City of Maple Plain

Request by Comfort Haven LLC for a Conditional Use Permit and Site Plan Review to Allow the Re-use of the Existing Building as Assissted Living Care Facility on the Property Located at 1520 Wyman Ave.

To: | Planning Commission

Meeting Date: | March 7, 2024

SITE PLAN

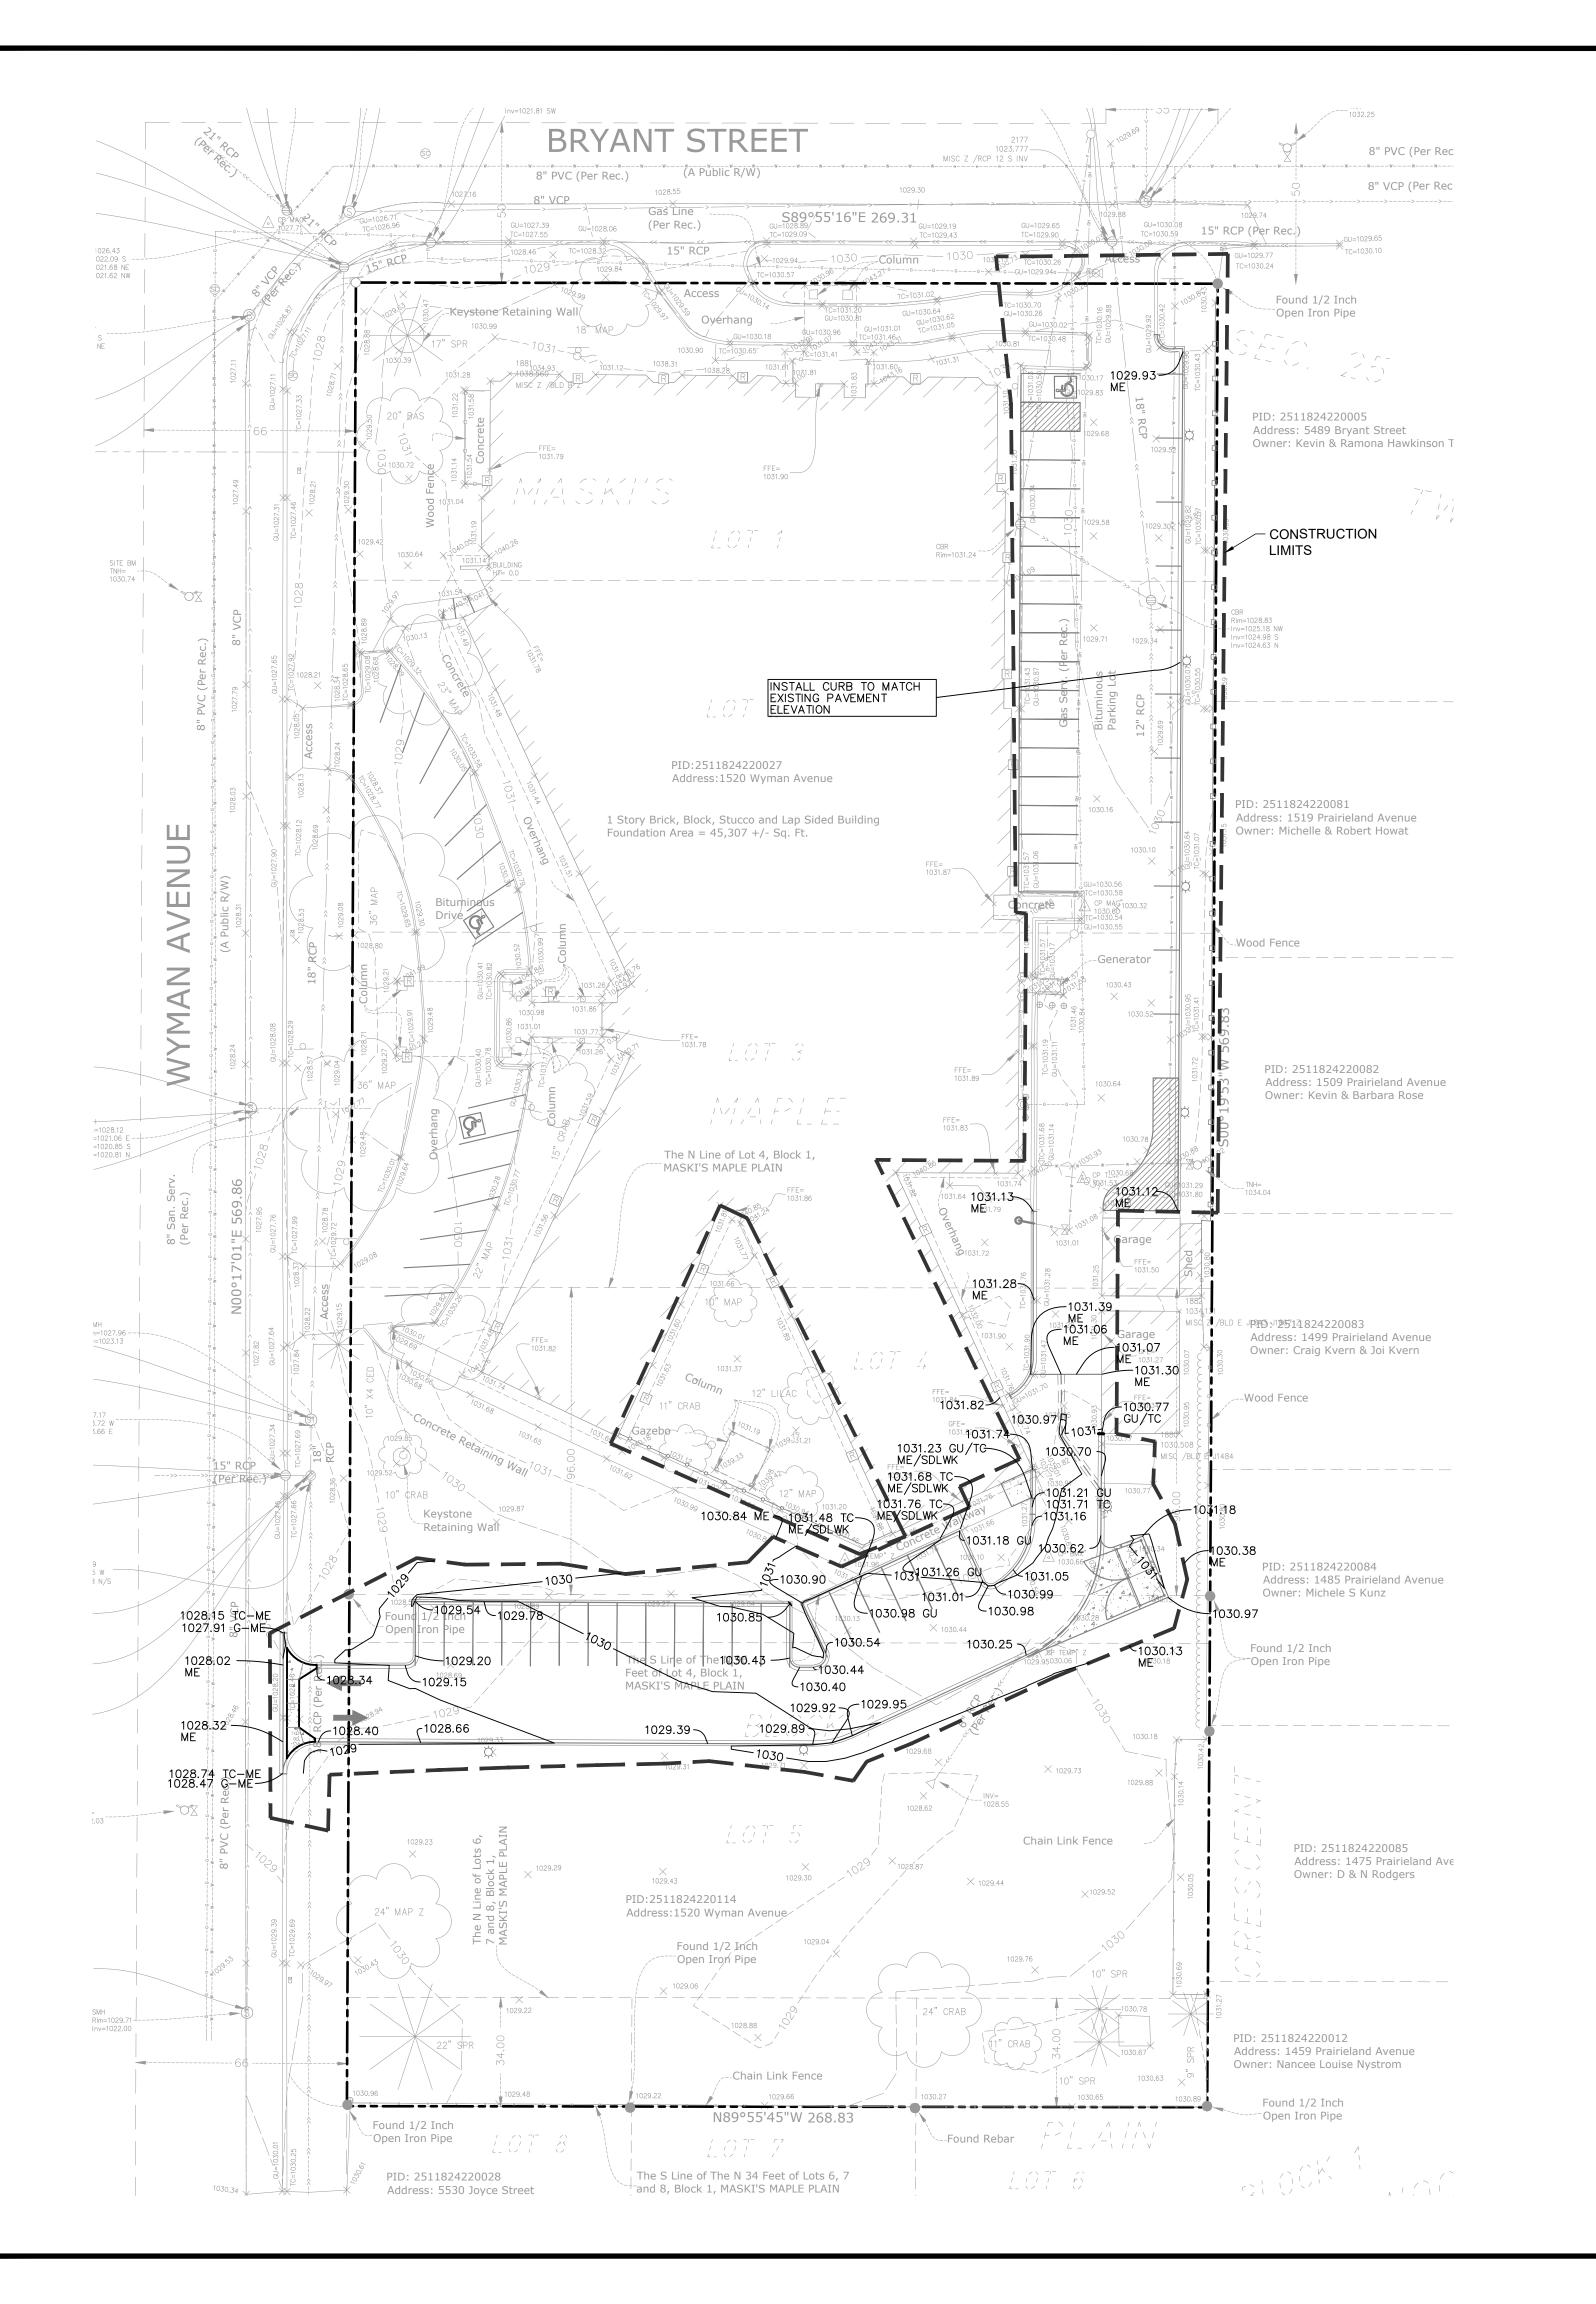
The existing facility includes two paved parking areas, landscaping, lighting several detached accessory buildings and a trash enclosure. The applicant is proposing to construct a new ingress/egress off of Wyman Avenue (see area highlighted in red below). This area will add new parking spaces as well as allow for access around the entire building permitter. As a result of the new parking area, the applicant is proposing to reduce the width of the existing parking lot which will pull it away from the residential properties to the east. The proposed reduction in pavement will establish an approximate 10' buffer and setback to the adjacent residential properties to the east.

The proposed plans indicate a total of 61 parking spaces which includes 14 existing parking spaces in front of the building. It appears that the proposed parking will meet applicable requirements.

The existing parking lot is paved; however, the pavement is in poor condition and the striping is no longer visible or highly worn. The applicant is proposing to mill and overlay and restripe the parking spaces in accordance with the proposed site plan.
